Access Compliance Report

Public Rights-of-Way

Intersection ID: 8350	Main Street: LASALLE_ST	Cross Street: CUSTER_ST	Location: NW
ADA ID: 0848E7208064	Ramp Type: Perp	Initial Pass/Fail: Fail	Overall Compliance: No
		Severity Score: 22.5

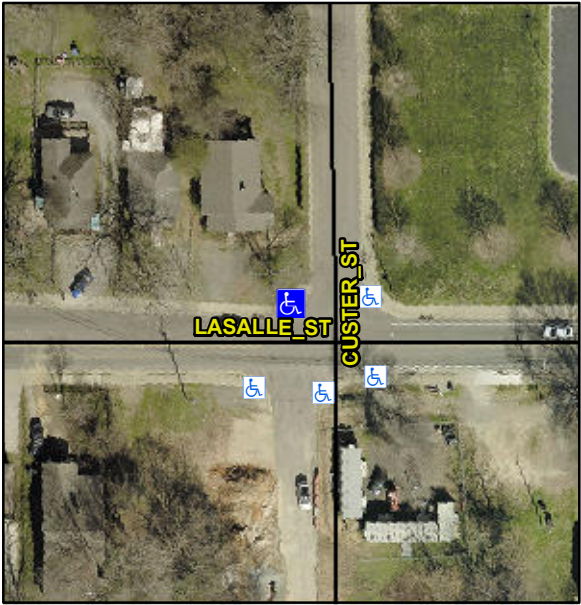
Codes/Mitigation Info/Possible Solution			Field Measurements/Component Compliance		
	Possible Solutions:		Compliance	Description	Data
	Remove & Replace Entire Ramp.		Compliance	Description	Data
	Surveyor Notes:		No	Ramp Length (in)	59.5
	N/A		No	Ramp Width (in)	40.0
	PROW/ADA:		N/A	Flare Type LT	N/A
	Not Found, R304.5.1, R304.2.2, R304.5.3		N/A	Flare Slope LT (%)	N/A
			N/A	Flare Traversable LT?	N/A
			N/A	Flare Slope RT (%)	N/A
			N/A	Flare Traversable RT?	N/A
			N/A	DWS Provided?	N/A
			N/A	DWS Contrast?	N/A
			N/A	DWS Length (in)	N/A
			N/A	DWS Full Width?	N/A
			N/A	DWS Offset (in)	N/A
			N/A	Shared Landing?	N/A
			N/A	Gutter Ponding?	N/A
			N/A	Gutter Lip Ht (in)	N/A
			No	Painted X Walk1?	N/A
			To SE	X Walk 1 Direction	N/A
			N/A	X Walk 1 Width (in)	N/A

0.1	X Walk 1 Slope (%)	N/A
			3.9	X Walk 1 X Slope (%)	N/A
			N/A	Ramp inside XWalk1?	N/A
			N/A	Ramp inside XWalk2?	N/A
			N/A	Road Slope (%)	N/A
			N/A	Road X Slope (%)	N/A
			N/A	Any Obstructions?	N/A
			N/A	Obstruction Type	N/A
			N/A	Clear Space?	N/A
			N/A	Clear Space to XWalk (in)	N/A
			N/A	Storm Grate/Utility Hazard?	N/A
			N/A	Storm Grate/Utility Type	N/A
			Yes	Surface Condition? (G/P)	Good
